The City of New York
Office of the Mayor
OFFICE OF EMERGENCY MANAGEMENT
100 Church Street - 20th Floor
New York, NY 10007

To: Glen Pymeto DCAS
From: John E. Hughes OEM
Subject: 7 WTC Construction Variations
Date: October 27, 1998

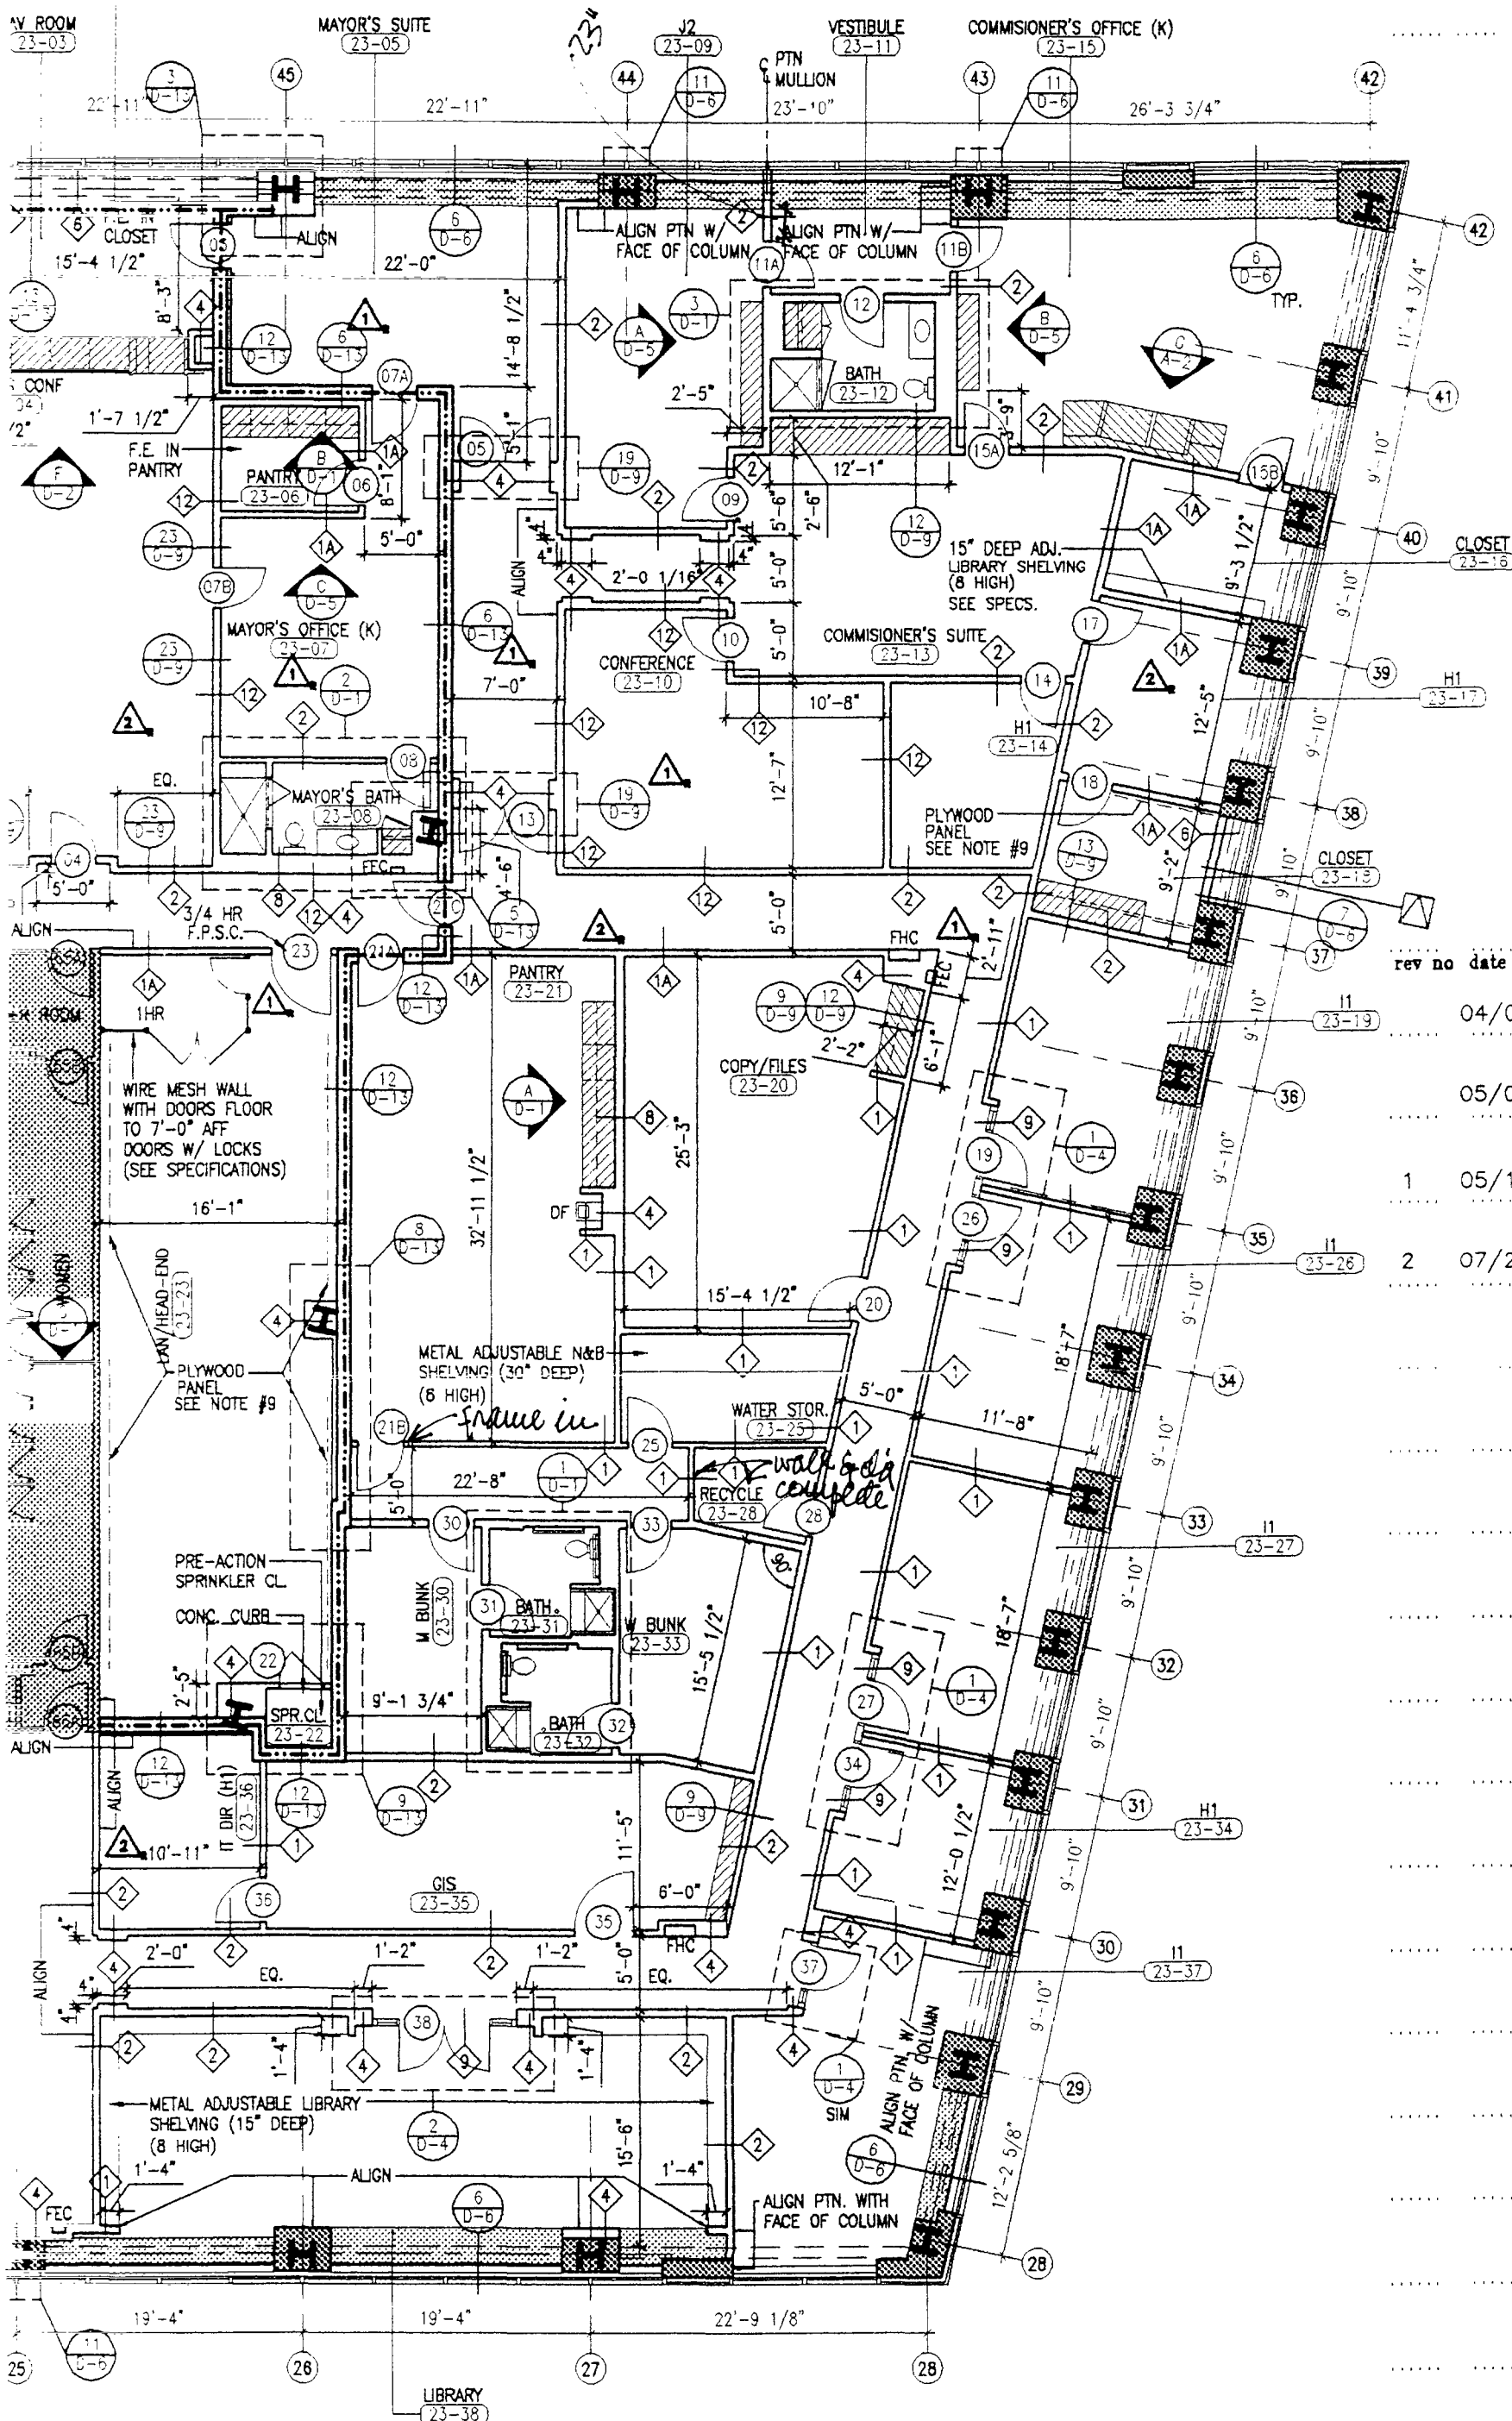
- Commissioner's Suite (23-13)- - a "call button" for the freight and passenger elevators and an intercom to the main entrance reception area and Mayor's conference room at the receptionist's desk *Bldg. Manager is not permitting this!!*

- Commissioner's and First Deputy's Vestibule (23-11) - - a counter top stretching along the north wall to accommodate a coffee station and small refrigerator underneath. *Counter will interfere with doors. There is already (1) ref. at 3H's; always a outlet is for coffee maker.*

- Recycle Area (23-28) - - open up the partition wall and incorporate the recycle and water storage area (23-25) into one space. This provides egress and access into the bunk rooms from the public hallway and eliminates the rear entry door into the cafeteria. (See attached.) *Access should be from EOC room; not from public hallway. Recycling room should not be eliminated*

- Main Reception and Elevator Lobby - - provide a phone and/or intercom system to the receptionist's desk from the hallway. Maintain a line of sight for the receptionist. *Both things are on drawings*
